# Sign Type: With pole covers in Place

**AVALANCHE**  
SIGN CONTRACTING  
786 Hathaway Drive • Colorado Springs, CO 80915  
Phone: 719.471.9898 • Fax: 719.632.7781

Project:  
Address:  
City/State:  
Sales Rep: JB  
Artist: KF  
Date: 01.17.17

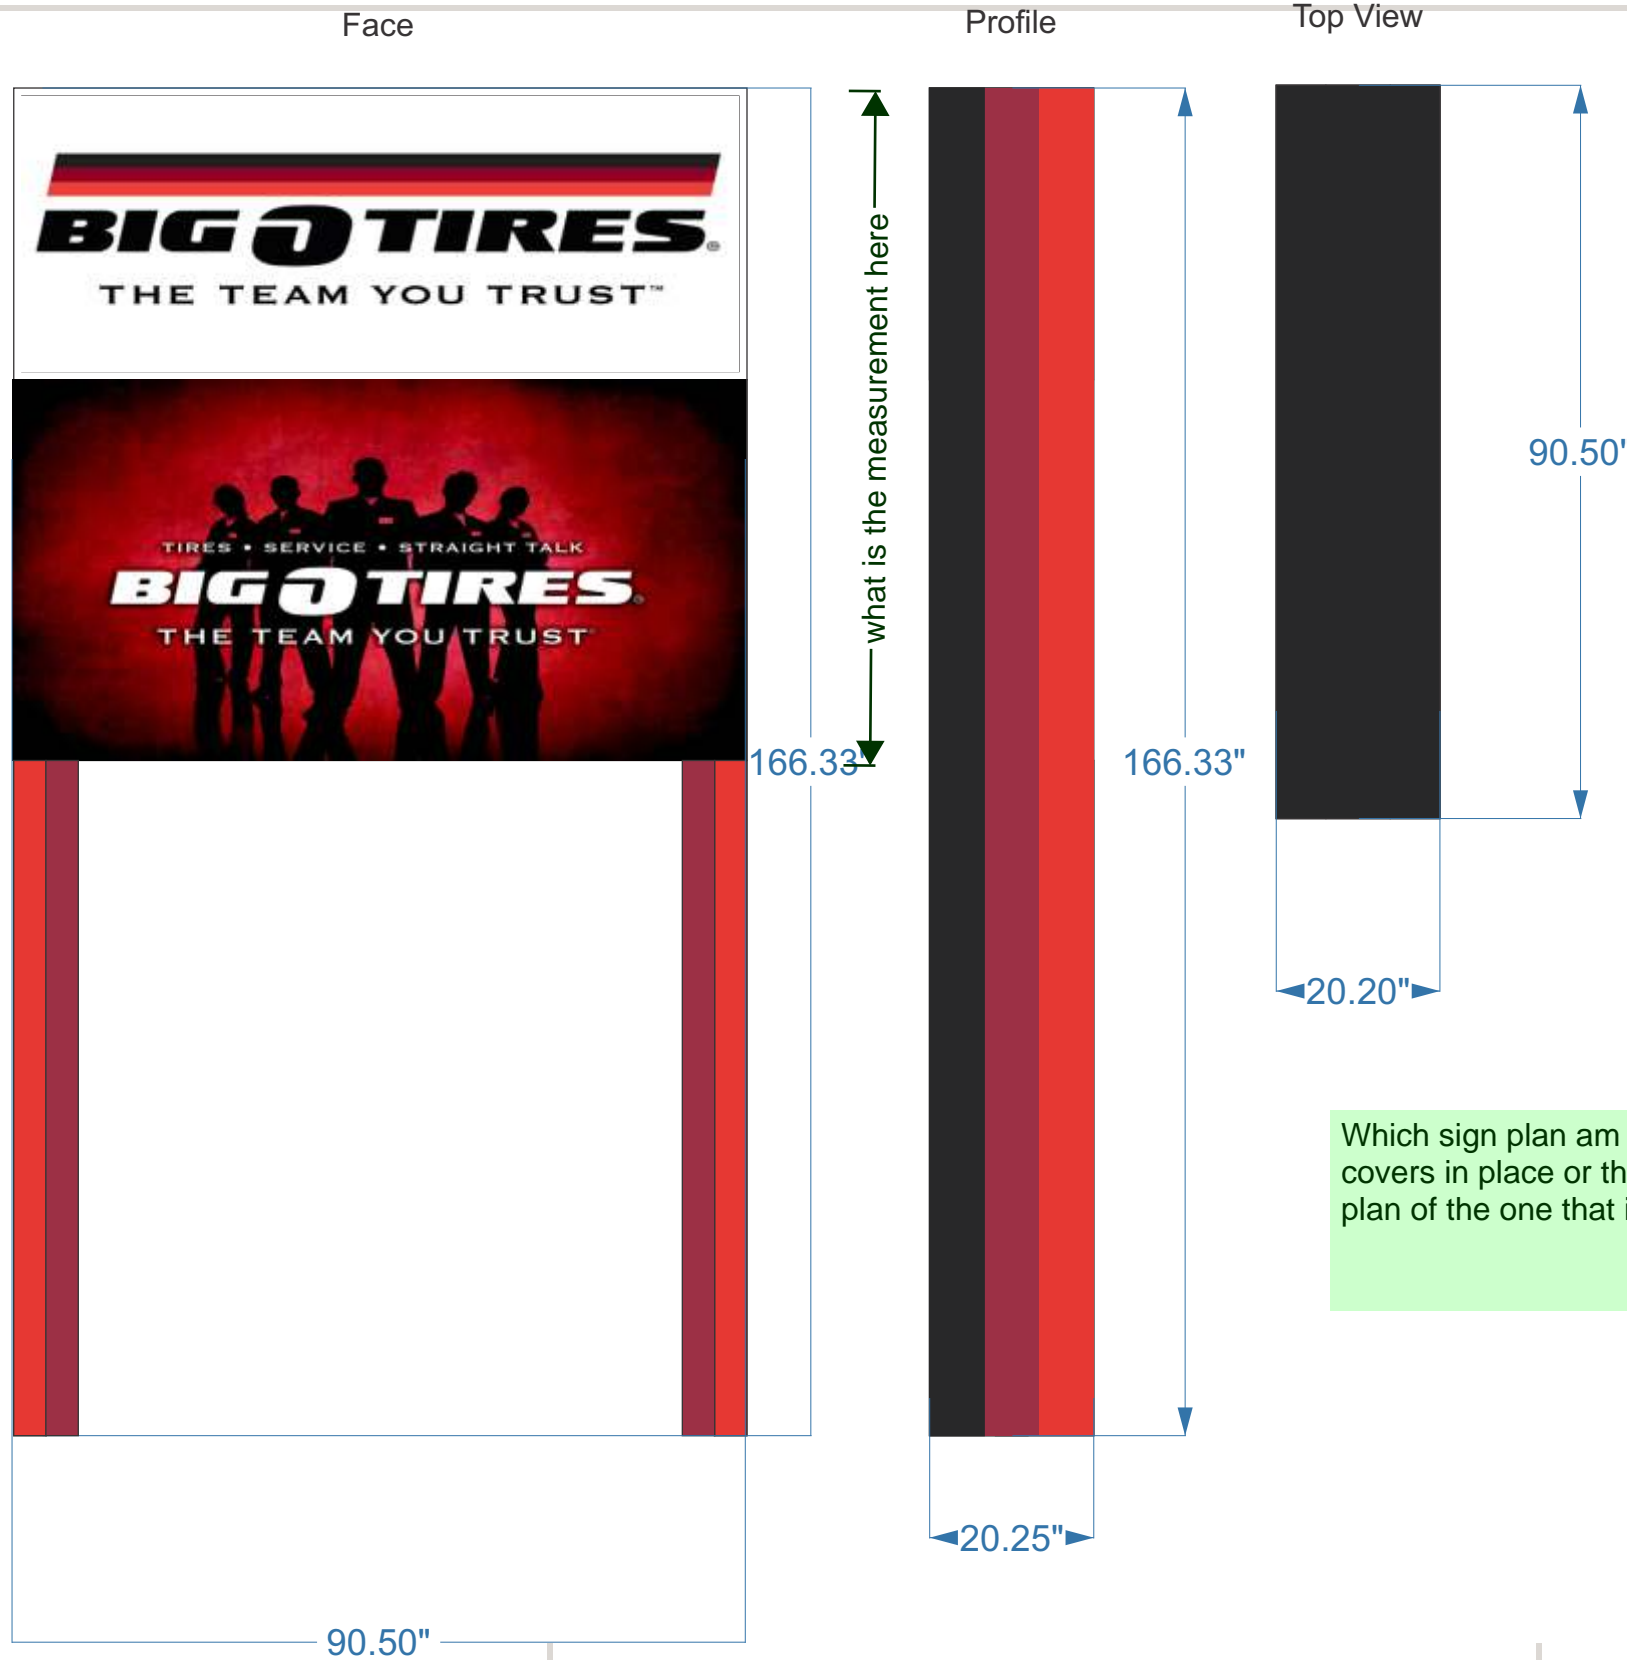
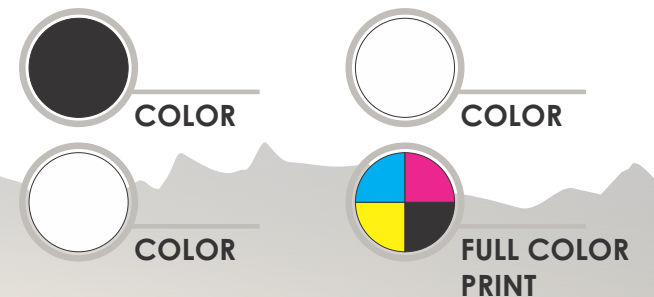
The total area of freestanding signs shall not exceed 2 square feet for each linear foot of the building wall closest to the freestanding sign or 40 square feet, whichever is smaller.

If there is an attached sign on the side of the building that is closest to the freestanding sign they combined must not be more than 40 square feet.

Because this is located on an arterial/expressway the freestanding signs allowable area shall be 125% of the sign area otherwise allowed by this code.

I need to see elevations of the structure showing height (the sign shall not be taller than the structure). I need to know if there is an attached sign on the same side that this sign is being proposed, and if there is an attached sign, I need to know the dimensions of that, in order to calculate the amount of sign area that is allowed with the 25% increase.

Which sign plan am I approving? The one with pole covers in place or the one without? Only resubmit the plan of the one that is going to be on the property.

what is the measurement here
